**Economic and Social Council**Distr.: General  
25 September 2012

**Economic Commission for Europe****Inland Transport Committee****World Forum for Harmonization of Vehicle Regulations****Working Party on Passive Safety****Fifty-second session**

**Regulation No. 44 (Child restraint systems)****Proposal for Supplement 7 to the 04 series of amendments****Submitted by the expert from France\***

The text reproduced below was prepared by the expert from the France on behalf of the Technical Services Group (TSG) on UN Regulation No. 44. It aims to clarify the lap strap interaction with the dummy and its assessment as well as improving the overturning test procedure in light of recent findings. The modifications to the current text of the UN Regulation are marked in bold for new or strikethrough for deleted characters.

### Load application device

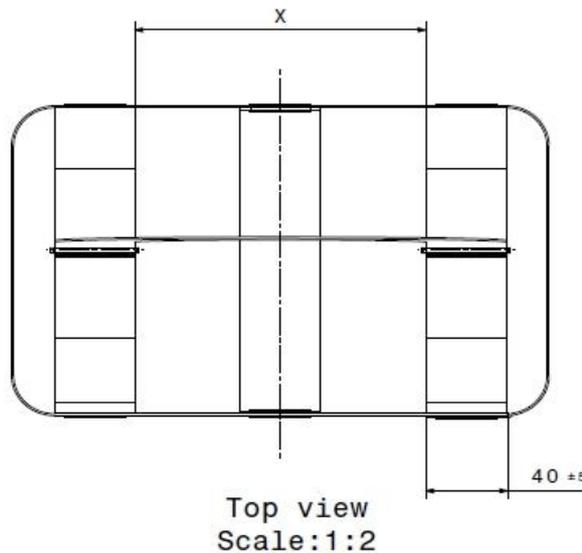
**8.1.2.3. At this static inverted position a total mass equivalent to [5] times that of the dummy shall be applied vertically downwards in a plane perpendicular to the axis of rotation to the dummy utilizing the load application device described in Annex 23. The load shall be applied at a rate not exceeding [400 mm/min]. Maintain the prescribed maximum load for a duration of [30 -0/+5] seconds.**

Insert a new Annex 23, to read:

4. *Paragraphs 7.1.3. to 8.1.2.7. and Annex 23*: The present test procedure does not adequately reflect the circumstances of real world rollover crashes. The procedure has been improved to reduce the existing differences between the test procedure and real accidents. A vertical quasi-static load is applied to simulate the dynamic behaviour of the child restraint systems and the dummy.
